CASE INFORMATION

CASE:	UDP-S23057
MEETING DATE:	November 28, 2023
REQUEST:	Site Plan Level II Review: Mixed Use Development Consisting of 257 Multifamily Units and 11,400 Square- Feet of Commercial Use in the Downtown Regional Activity Center
APPLICANT:	650 NORTH ANDREWS LLC
AGENT:	Stephanie Toothaker, Esq.
PROJECT NAME:	650 N Andrews
LOCATION:	Progresso 1-125 D Lots 1 Thru 10, Lots 40 Thru 47, 48,
ZONING DISTRICT:	Regional Activity Center – Urban Village District (RAC-UV)
LAND USE:	Downtown Regional Activity Center
CASE PLANNER:	Adam Schnell

Applicant REV 1 responses are bolded and dated December 12 2023
CITY REV 1 Comments

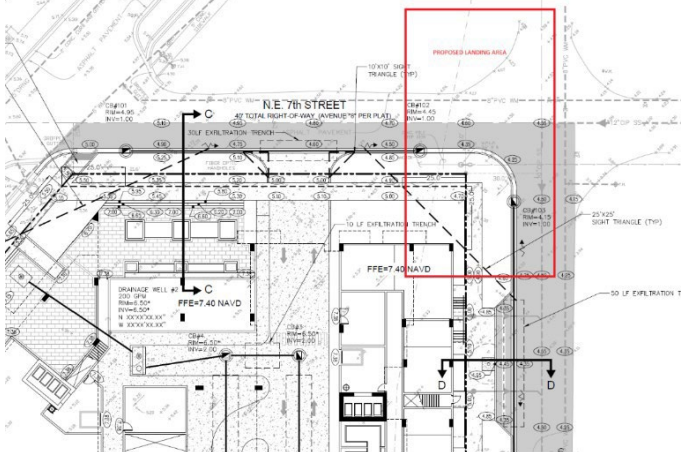
26. **NEW COMMENT:** Curb ramp at the intersection of NE 7th Street and NE 1st Avenue shall be eliminated to avoid directing pedestrians into an intersection with no landing on the opposing side. Landscaping buffer shall wrap the corner. Please revise sidewalk layout and update all necessary plans.

ENG RESPONSE (6/25/2024): In coordinating with the Traffic Engineer the city is requesting that a curb ramp at the southwest corner of NE 7th Street and NE 1st Avenue be installed as well as a curb ramp at the northwest corner of NE 7th Street and NE 1st Avenue for pedestrian accessibility. All plans shall be updated accordingly.

APPLICANT REV 4 RESPONSE: Two curb ramps have been added at the NE corner of the site, shown below. Landings have been provided in the right-of-way opposite of the new ramps as requested by the City. Refer to the Paving, Grading, and Drainage Plan, Sheet C2 for details.

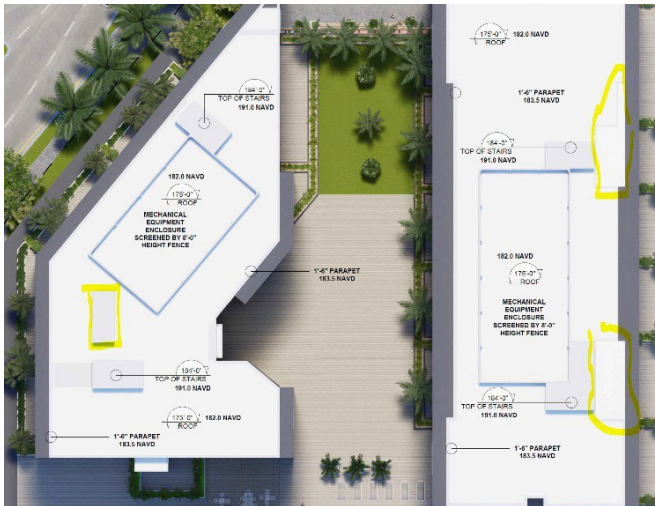
- d. Increase articulation of the building facades. Banding is an architectural element but cannot substitute building modulation. The use of banding around the perimeter of the towers and balconies needs to be reduced. Alternative architectural design features need to be integrated into the façade.

- Provide layered cornice.
- Corner elements should be carried vertically through the podium, with an angular design that matches the unique curvature of the northwest corner.
- Changes in texture and material between the podium and tower will help visually highlight the towers stepback.

• Double high windows with ornate treatment to match the height if the loft liner units.
Reference building design examples herein.

RESPONSE: Additionally architectural modulation and articulation is under consideration.

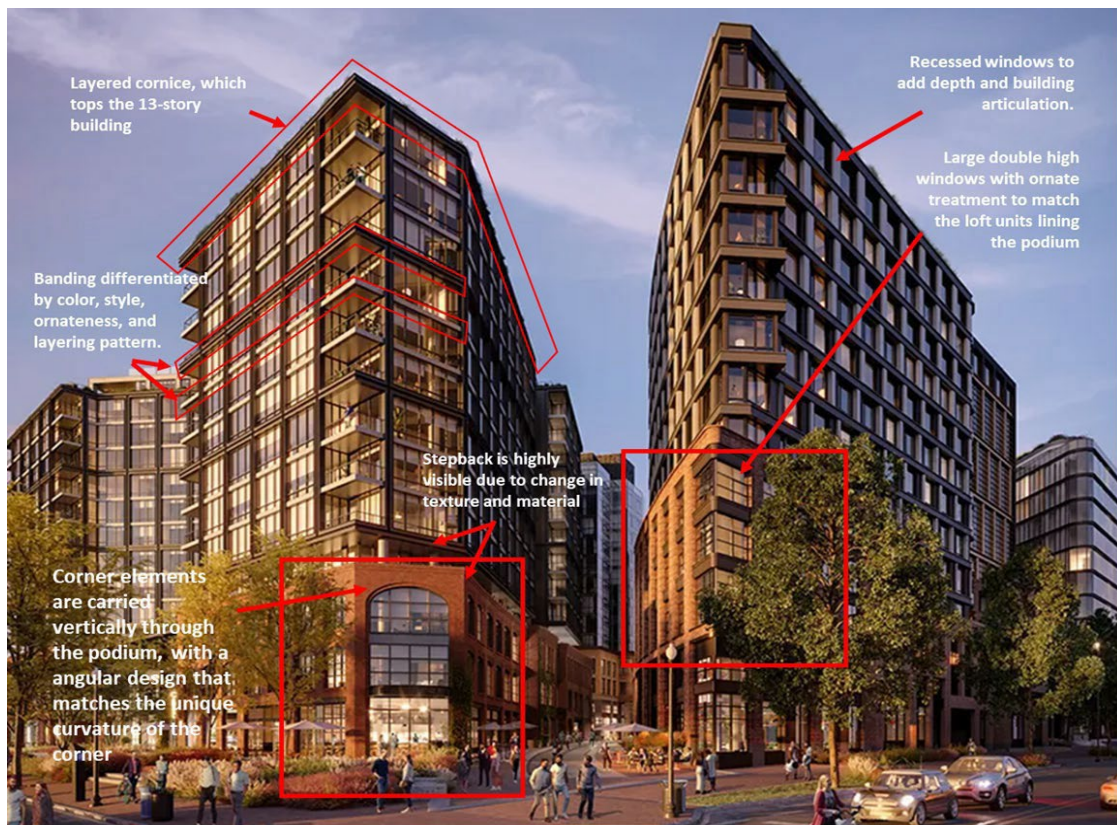
- g. An alternative design is needed in lieu of the 11 story murals such as windows and balconies. Murals are not intended to replace facade design features.

COMMENT: An alternative design solution needs to be explored to break up the size of proposed murals. Murals cannot be used as a design solution for highly visible vertical walls. The murals are approximately 112 feet in height and 28 feet in width, with over 3,150 square feet of surface area and 112 feet in height and 21 feet in width, with over 2,403 feet of surface area. The combined area of both murals exceeds 5,500 square feet. Additional discussion on the design of the eastern tower façade is required.

RESPONSE: Wrap-around balconies were added to animate the back wall behind elevators. REV1

RESPONSE: Balconies were added in front of those two murals. The added balconies cut the massiveness of the two mural walls. Please see updated rendering on Sheet A-906, showing a more dynamic facade, and the blank walls more subdued.
